February 7, 2023

ADDENDUM NO. 3

**PROJECT #21030 - Jefferson Co. Jerry Ware Terminal and ARFF Station
Rehabilitation
BEAUMONT, TEXAS**

Sheet E3.1- Revised and Attached
Power Plan – 1st Floor

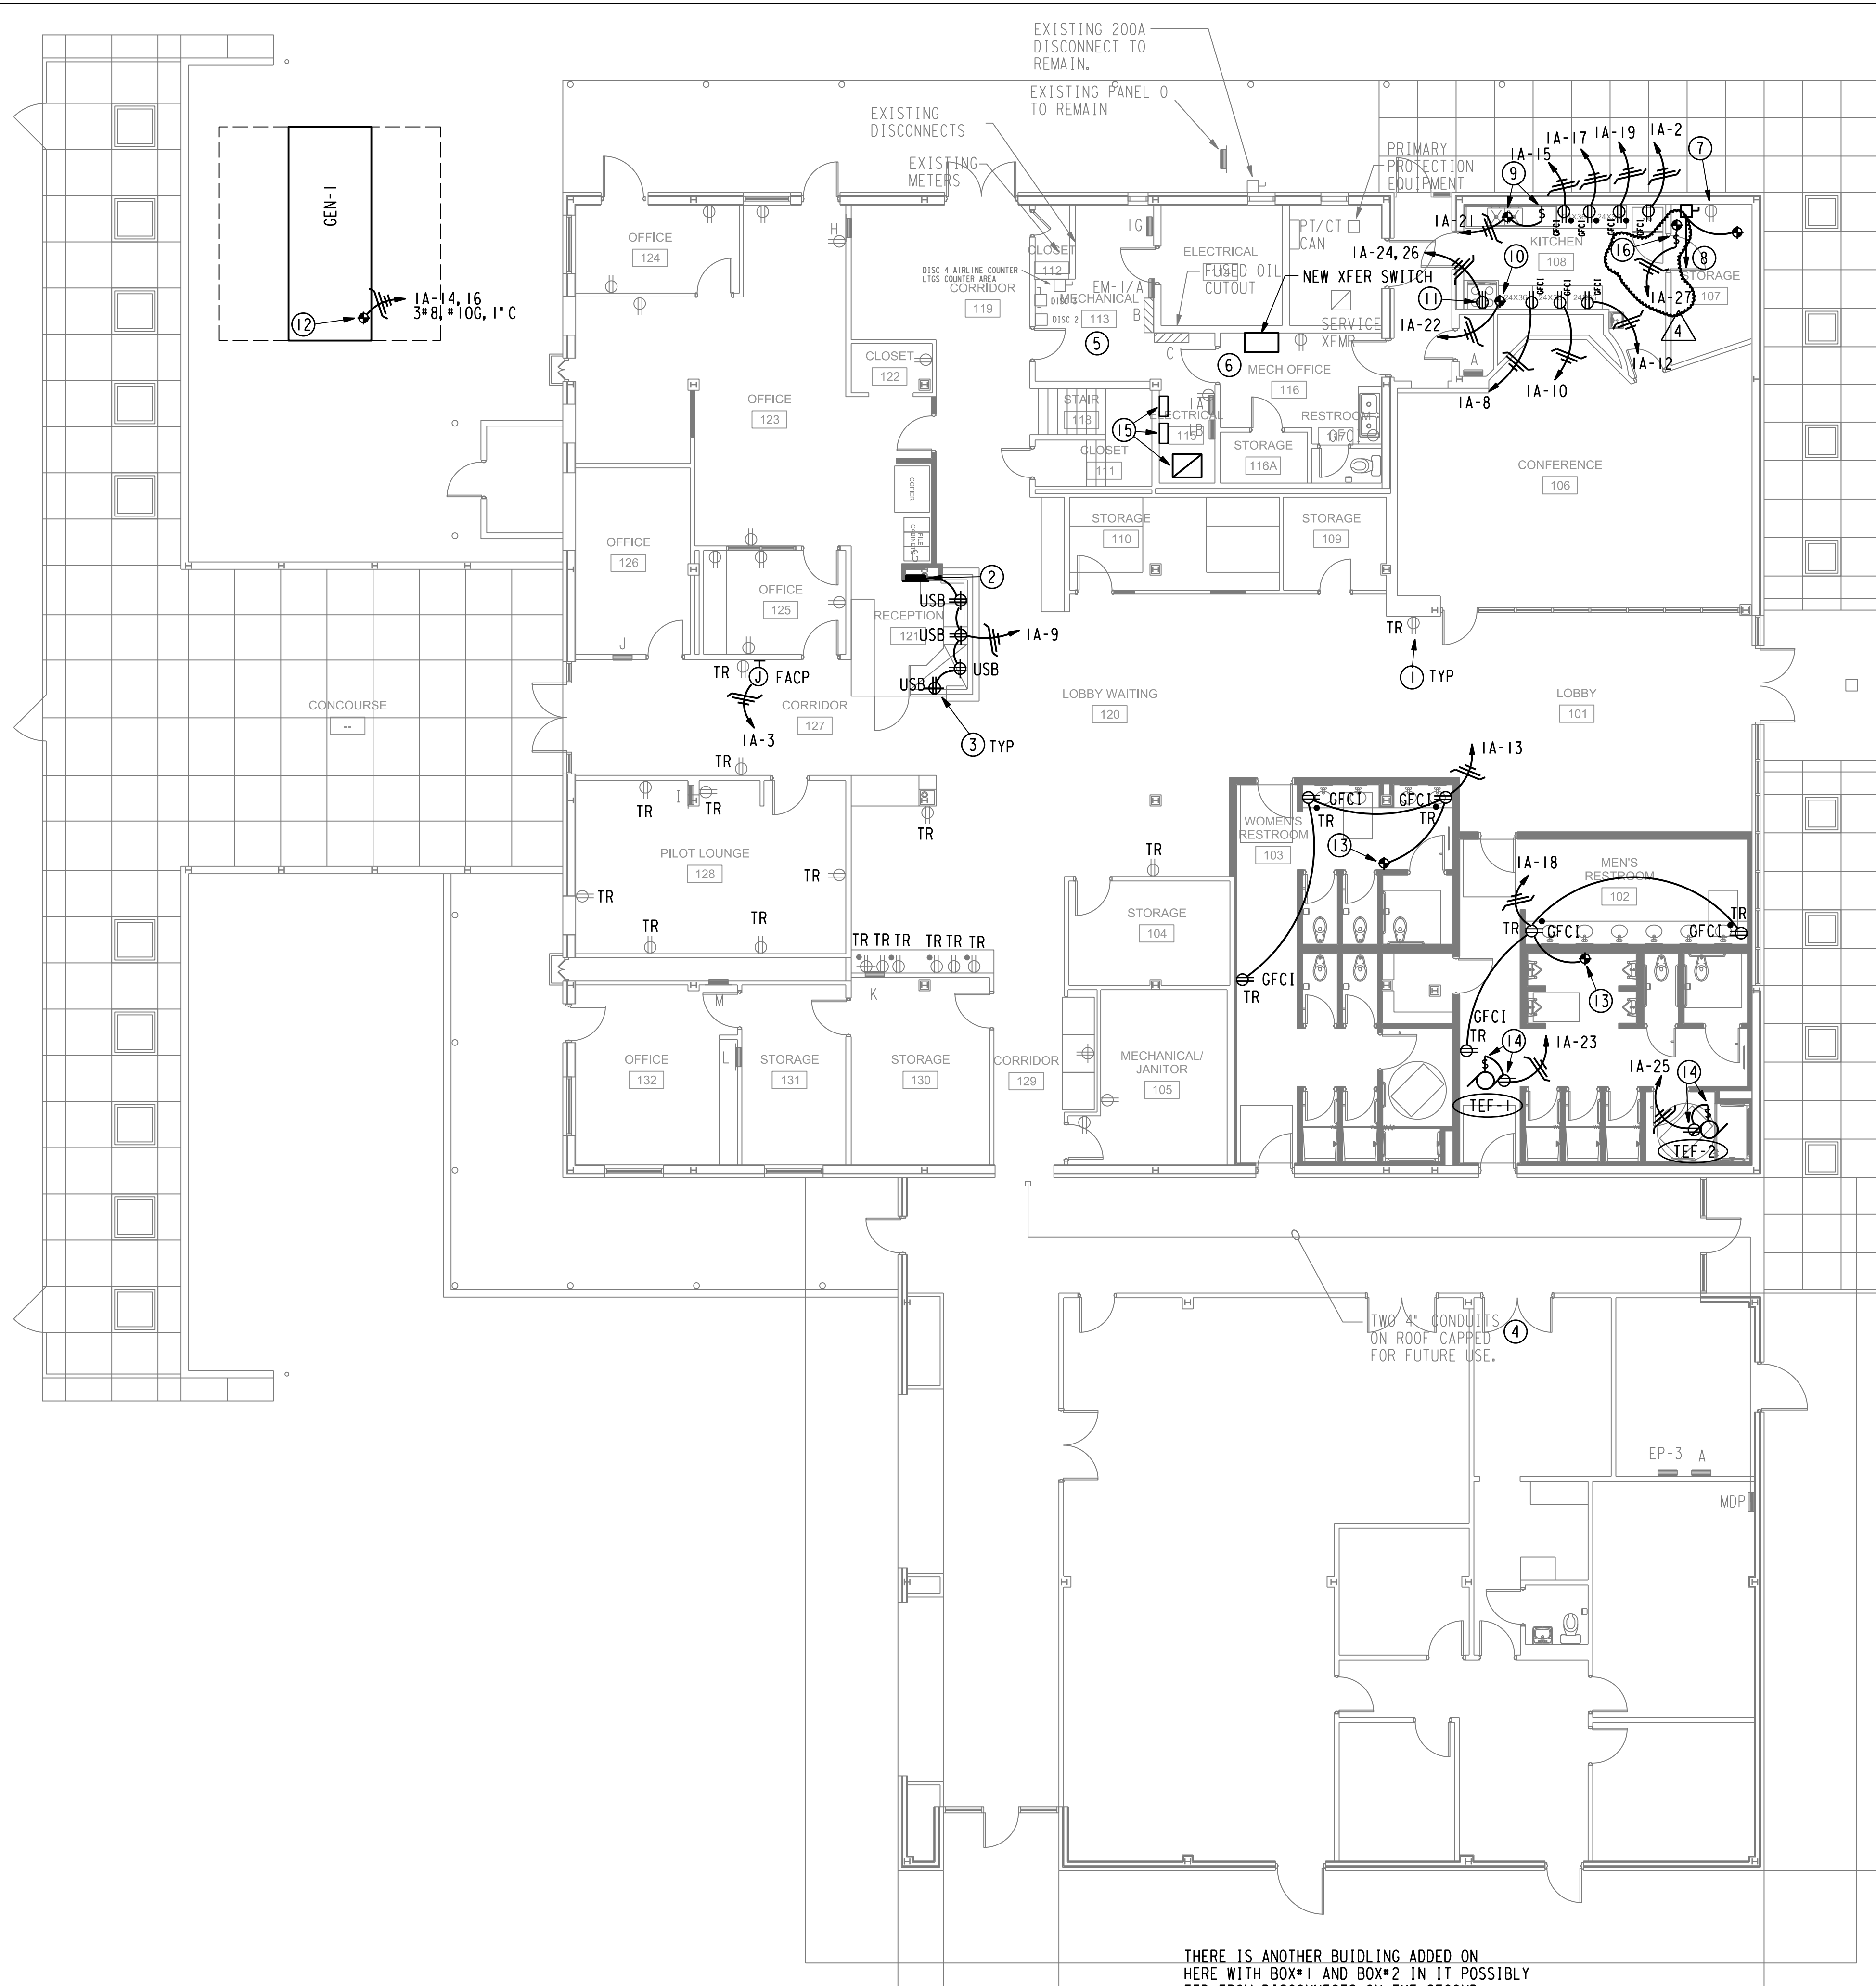
1. See plan for location and power for hot water circulation pump: Note 16 and as shown on plan.

- NEW 112.5KVA TRANSFORMER AND PRIMARY AND SECONDARY DISCONNECTS TO BACKFEED/PANEL MDP. RE: ONE-LINE FOR SIZES AND ADDITIONAL INFORMATION.
- POWER FOR HOT WATER CIRCULATION PUMP. PROVIDE 120V, 20A, SINGLE POLE MOTOR RATED TOGGLE SWITCH MAINTENANCE DISCONNECT FOR CIRCULATION PUMP. MAKE CONNECTION TO PUMP AS REQUIRED.
